## DEVELOPMENT ASSESSMENT REPORT

<b>Application No.</b>	DA/2021/0848
<b>Address</b>	42 College Street BALMAIN NSW 2041
<b>Proposal</b>	Alterations and additions to dwelling at ground and first floor, new pool and tree removal.
<b>Date of Lodgement</b>	14 September 2021
<b>Applicant</b>	Ballast Point Pty Ltd
<b>Owner</b>	Ms Emma L Bull
<b>Number of Submissions</b>	19
<b>Value of works</b>	\$585,000.00
<b>Reason for determination at Planning Panel</b>	Number of submissions
<b>Main Issues</b>	Tree loss, Design in Conservation Area
<b>Recommendation</b>	Approved with Conditions
<b>Attachment A</b>	Recommended conditions of consent
<b>Attachment B</b>	Plans of proposed development
<b>Attachment C</b>	Heritage Impact Statement
<b>Attachment D</b>	Arborist report

**STORMWATER MANAGEMENT PLAN**

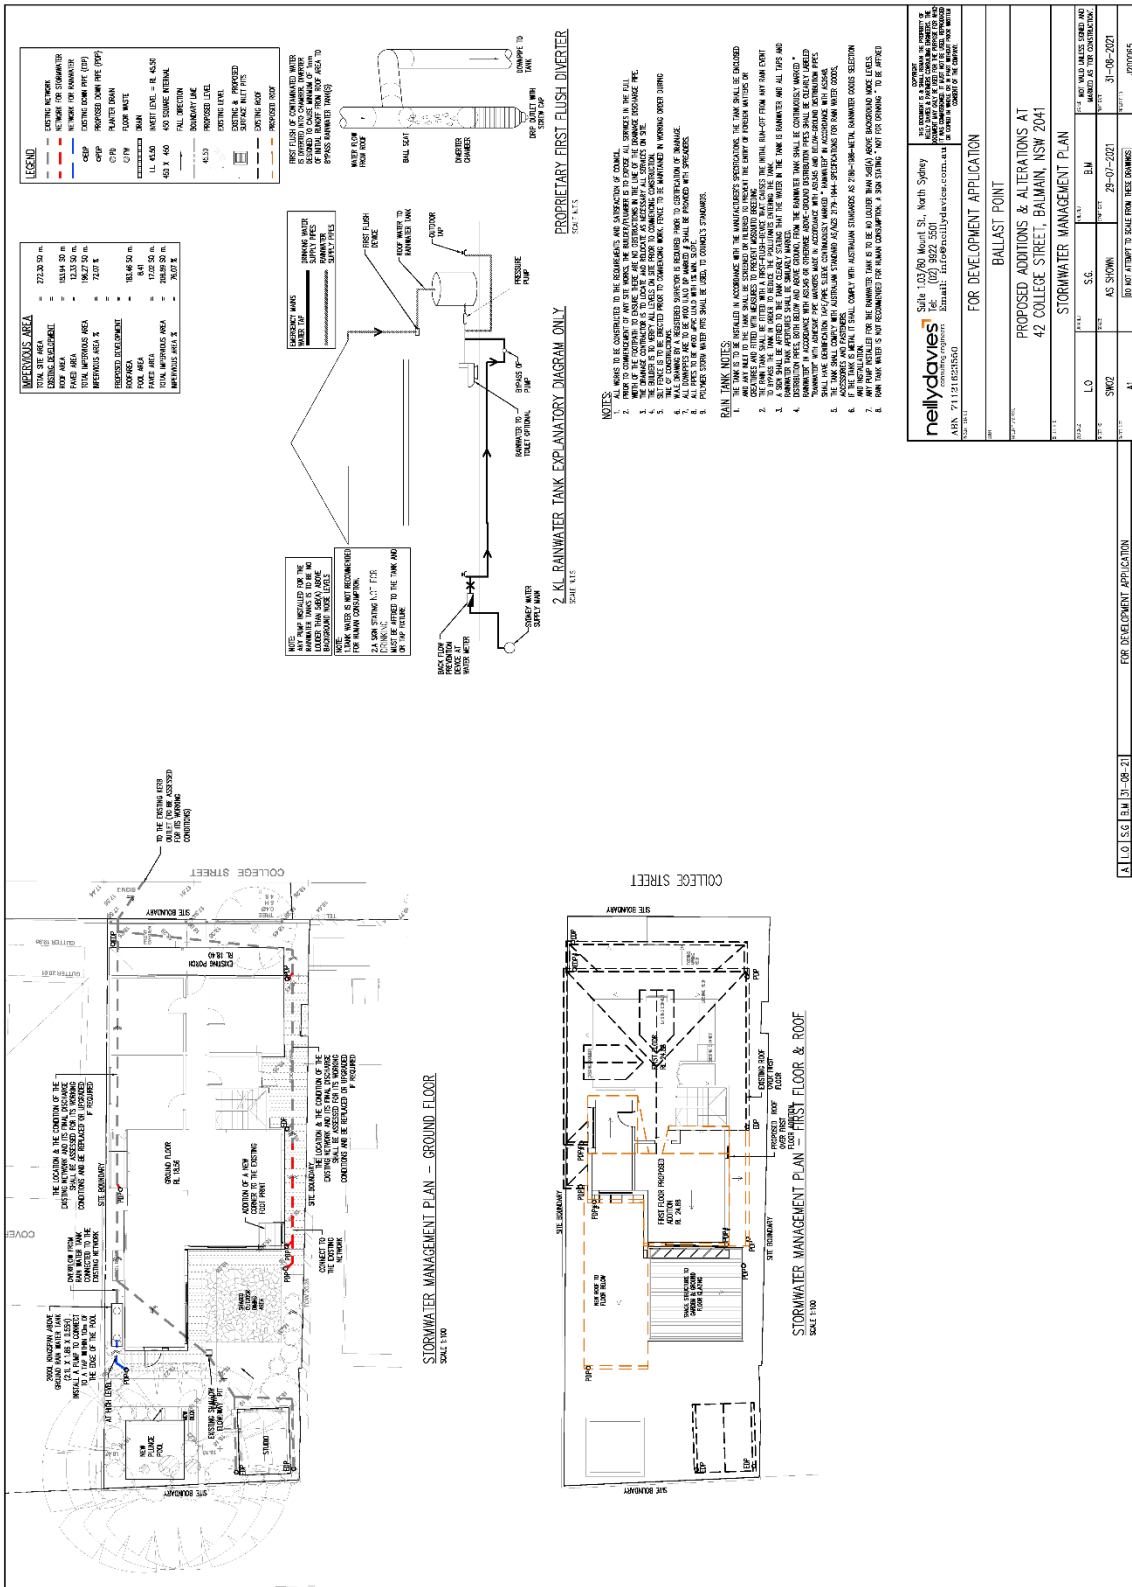
- a. The Stormwater Drainage Concept plan on Drawing No. SW02 prepared by Neilly Davies and dated 31 August 2021, must be amended to comply with the following;
